# ATTACHMENT BOOKLET 4

**ORDINARY COUNCIL MEETING**

**TUESDAY 24 SEPTEMBER 2013**

**RECONCILIATION OF NATIONAL PARKS & WILDLIFE SERVICE HOLDINGS  
WARRINGAH LOCAL ENVIRONMENTAL PLAN 2011**

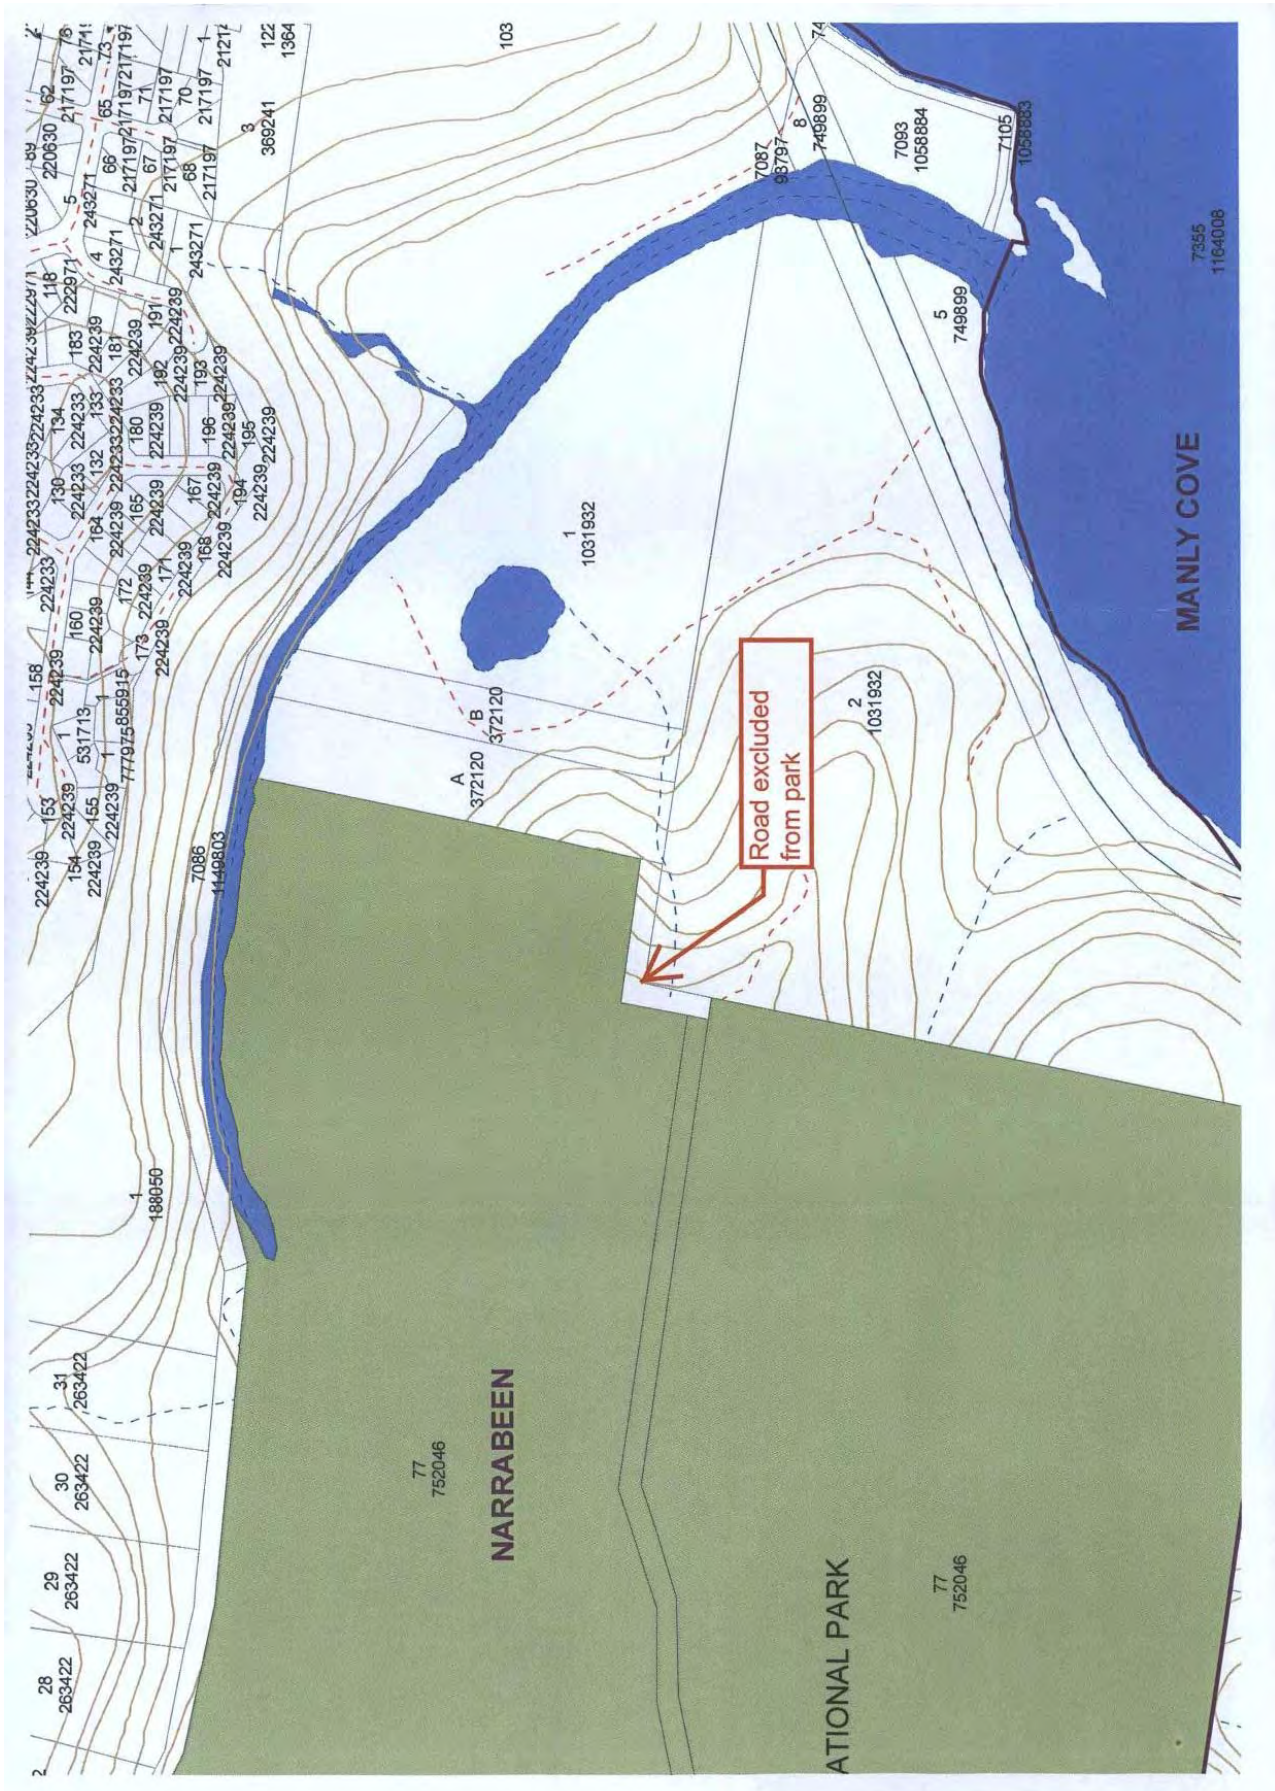
OEH has reviewed the planning proposal including the proposed amendments to the LEP maps. Council is advised that all OEH lands have been identified correctly with the exception of lands on the Area 12 Land Zoning Map. The attached map depicts the correct definition of the park boundary at this location. It is requested that Council amend the Area 12 Land Zoning Map to reflect the correct boundary prior to the public exhibition of the planning proposal.
